AGENDA
Molalla Planning Commission
6:30 PM, August 5, 2020

Date: July 27, 2020 for the August 5, 2020 Planning Commission Meeting

CASCADE CENTER/ LOTS 1, 2, AND 3
SHELL BUILDINGS

SITE PLAN REVIEW

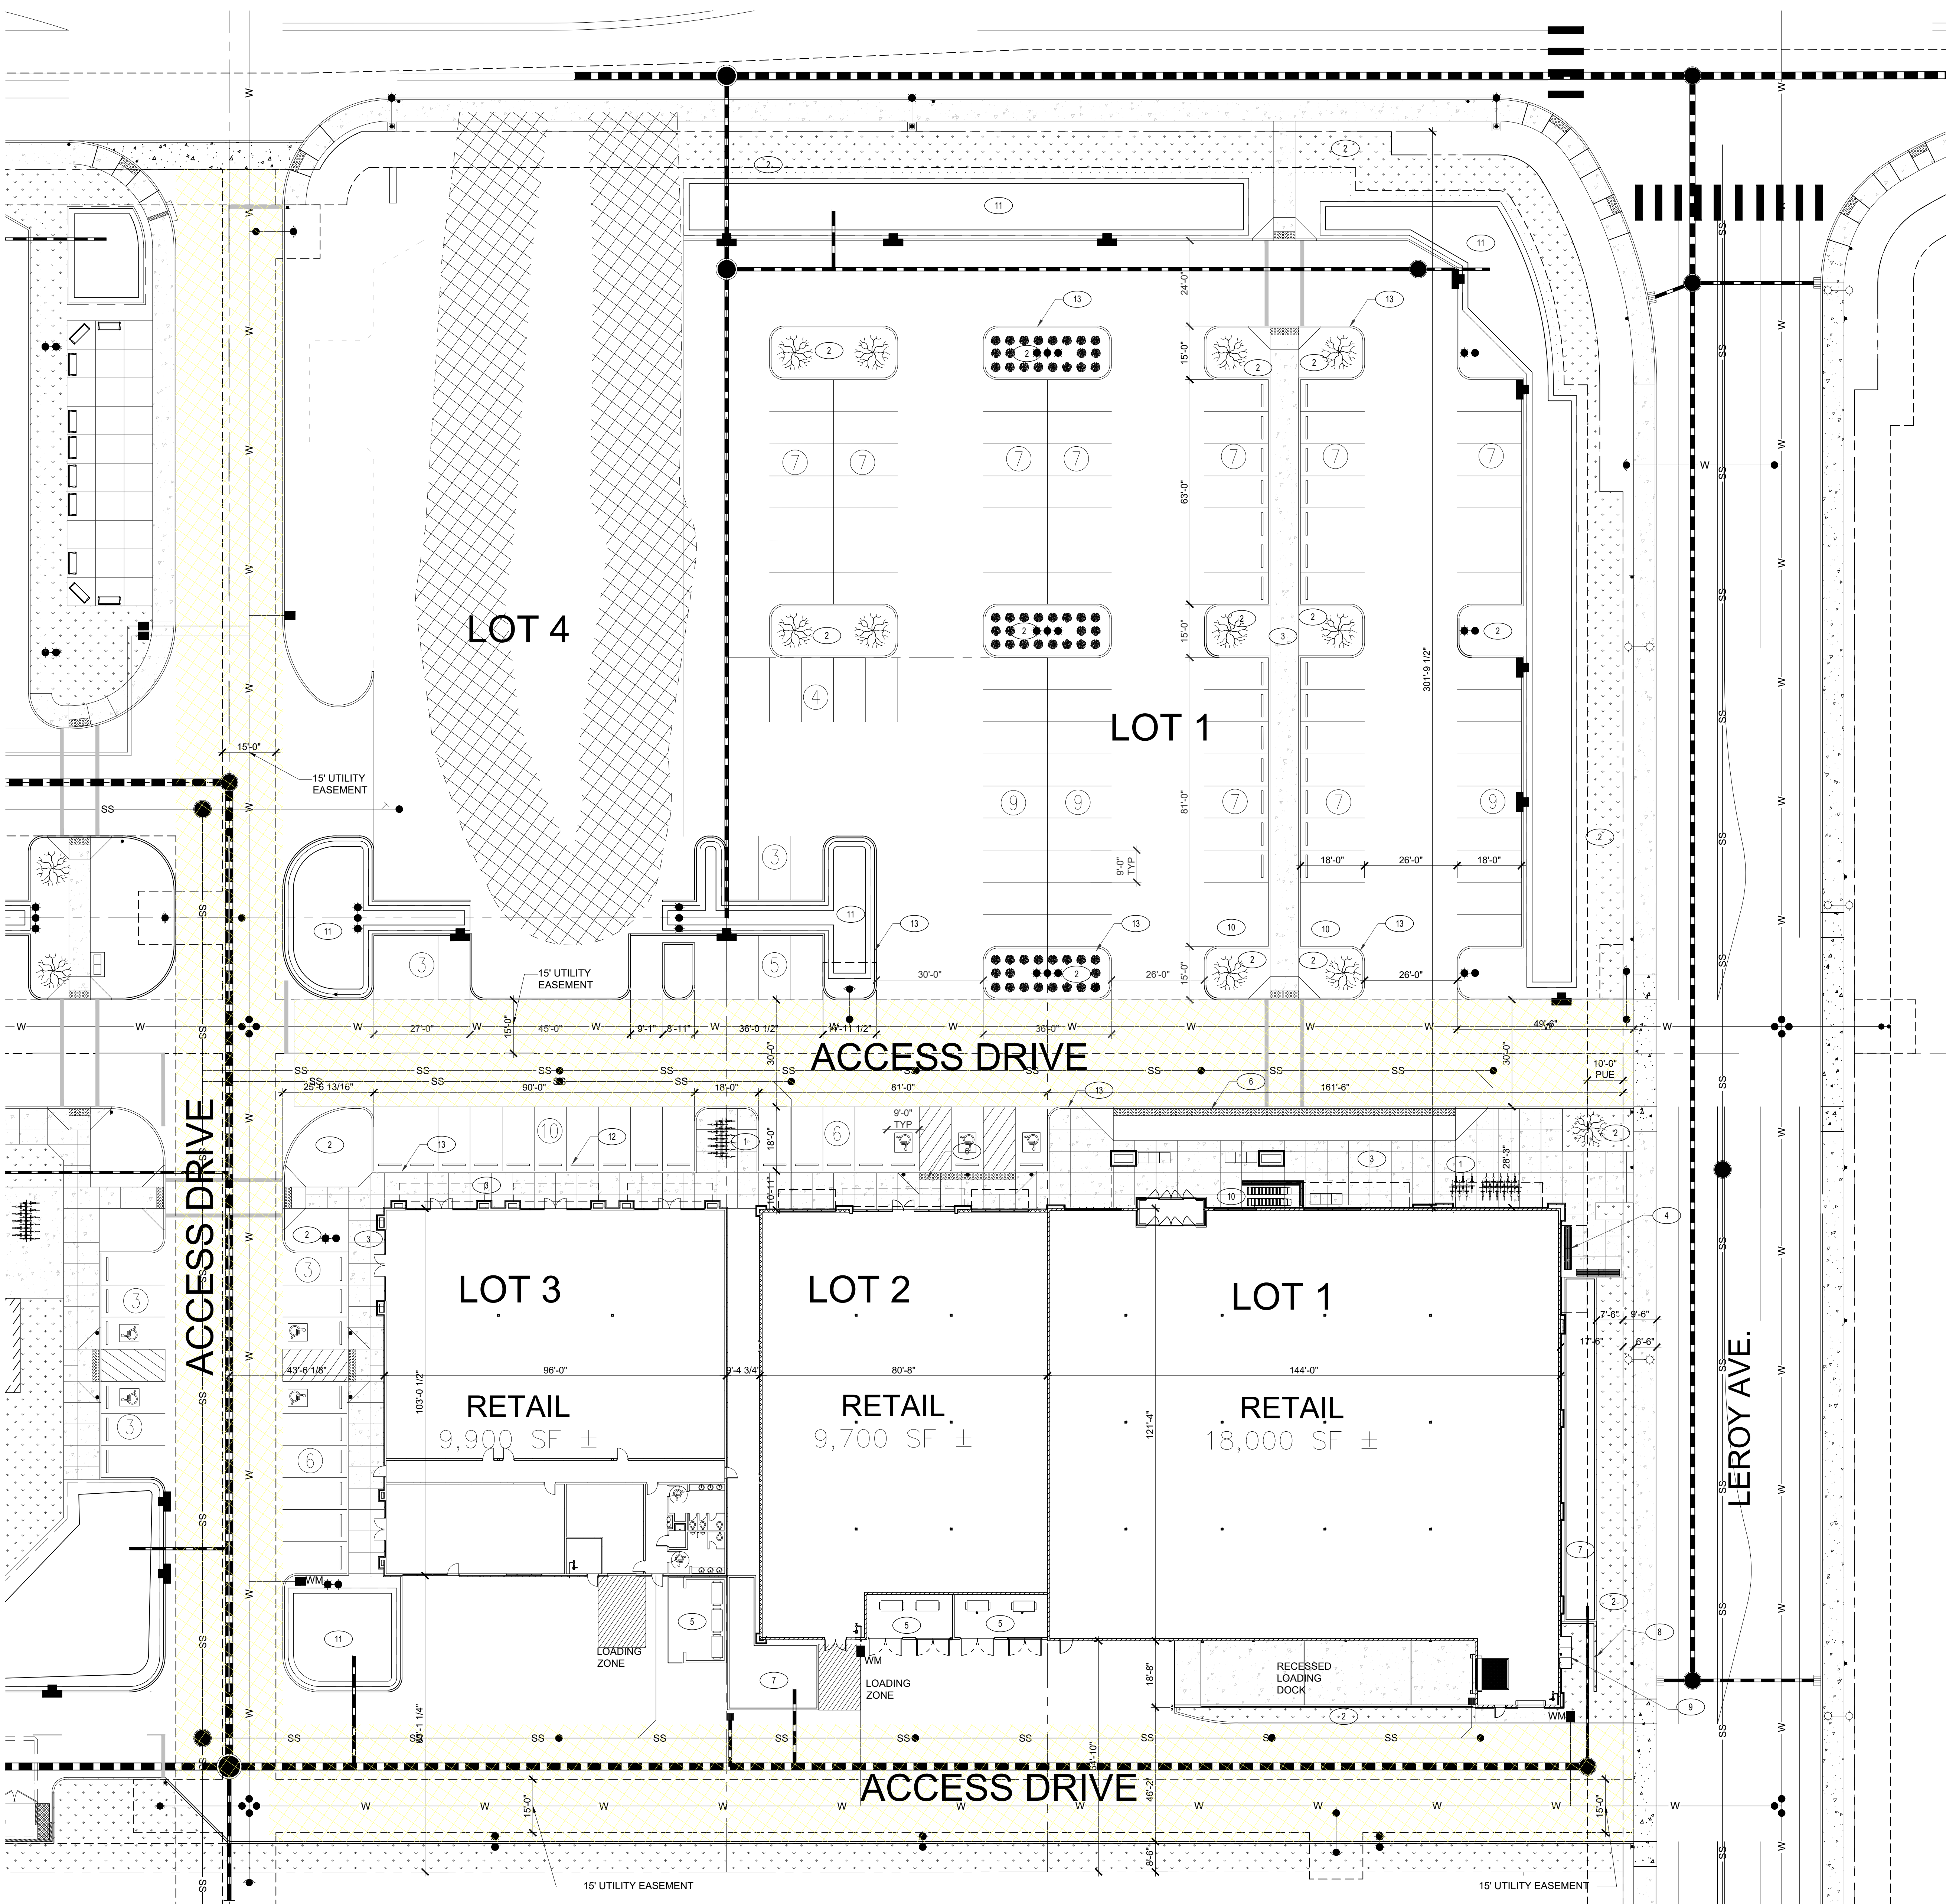
Findings: The Applicant's submitted site plan (Sheet A0) shows "electrical service main switch gear near the northeast corner of the building. It is not clear if this gear is ground or wall mounted. As a condition of approval, the Applicant shall provide detail showing that all proposed mechanical equipment shall be appropriately sited and screened in compliance with Section 17-2.040 G of Molalla Municipal Code.

- f. The Applicant shall provide detail showing that all proposed mechanical equipment shall be appropriately sited and screened in

2 SOUTH ELEVATION
 SCALE: 3/32" = 1'-0"

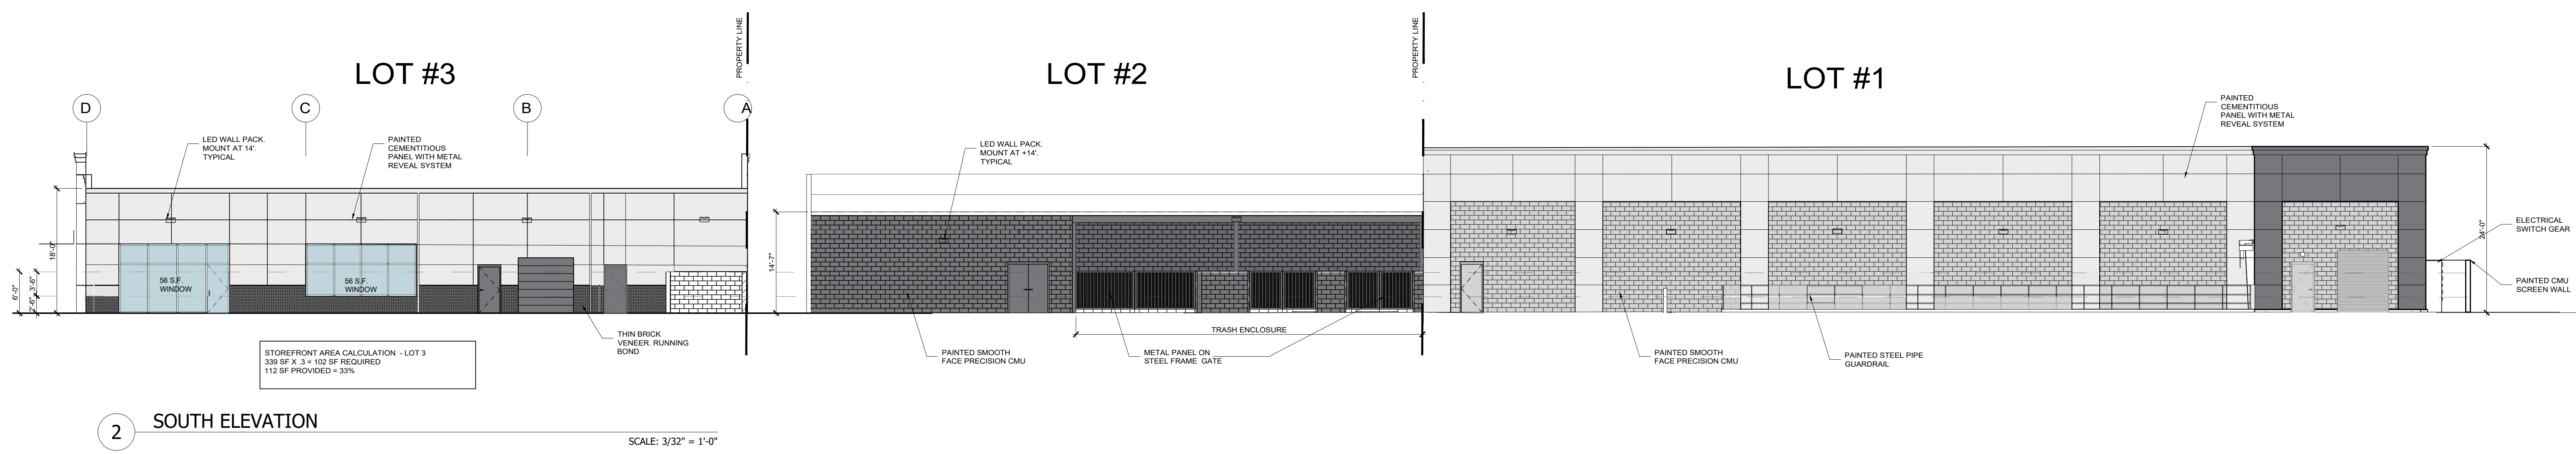
Findings: Staff finds that the Applicant's submitted elevations do not show appropriate breaks on the southern elevation of Lot 2. As a condition of approval, the applicant shall design the southern elevation to provide visual relief in accordance with articulation provisions.

Findings: Staff finds that the Applicant's submitted elevations do not show appropriate change in materials on the southern elevation of Lot 2. As a condition of approval, the applicant shall design the southern elevation to provide visual relief in accordance with articulation provisions.

- d. The applicant shall design the southern elevation to provide visual relief in accordance with articulation provisions (MMC Section 17-3.2.040, E, 1).

- e. The applicant shall design the southern elevation to provide visual relief in accordance with articulation provisions (MMC Section 17-3.2.040, E, 2).
